KANGOO CLIO II

36 WHINING FROM POWER ASSISTED STEERING WHEN MANOEUVRING

Title: Replacing the power assisted steering piping.

Fig. 1

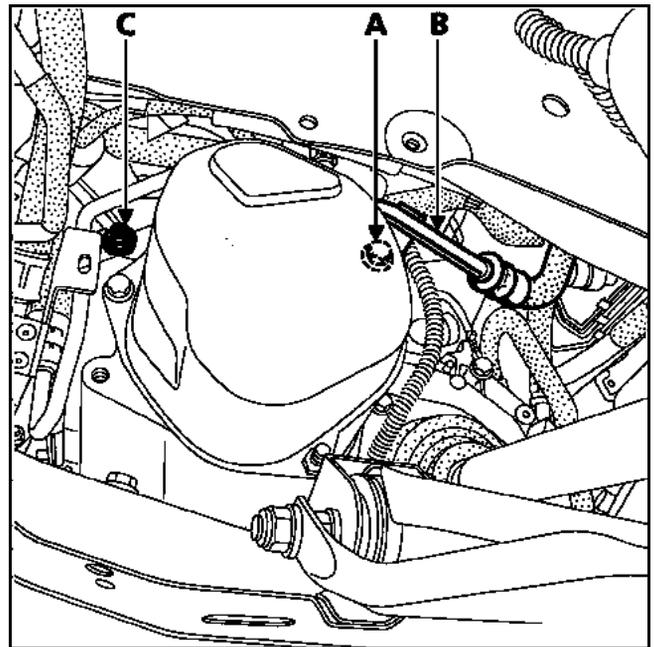
- Disconnect the battery.
- Remove:
 - the left hand front wheel,
 - the mudguard.
- Disconnect the pump assembly connector.
- Remove:
 - the earth strap on the gearbox,
 - the pump assembly pipes.
- Fit:
 - low pressure pipe **part no.: 82 00 033 764** on the original mounting points without connecting it to the pump assembly bottle,
 - stud **part no.: 77 03 027 328** instead of the upper bolt (A) (**Fig. 1**) on the 5th gear gearbox housing.

- Fit high pressure pipe (B) (**Fig. 1**) by attaching it to the stud (A) (**Fig. 1**) using nut **part no.: 77 03 033 025**, and using the bolt (C) (**Fig. 1**) **part no.: 77 03 002 072**.
- Connect the low pressure pipe to the pump assembly bottle.
- Adjust the power assisted steering circuit.
- Refit the assembly in the reverse order to removal.
- Reinitialize the components which were deprogrammed following disconnection of the battery before returning the vehicle to the customer (Clock, Radio Code).
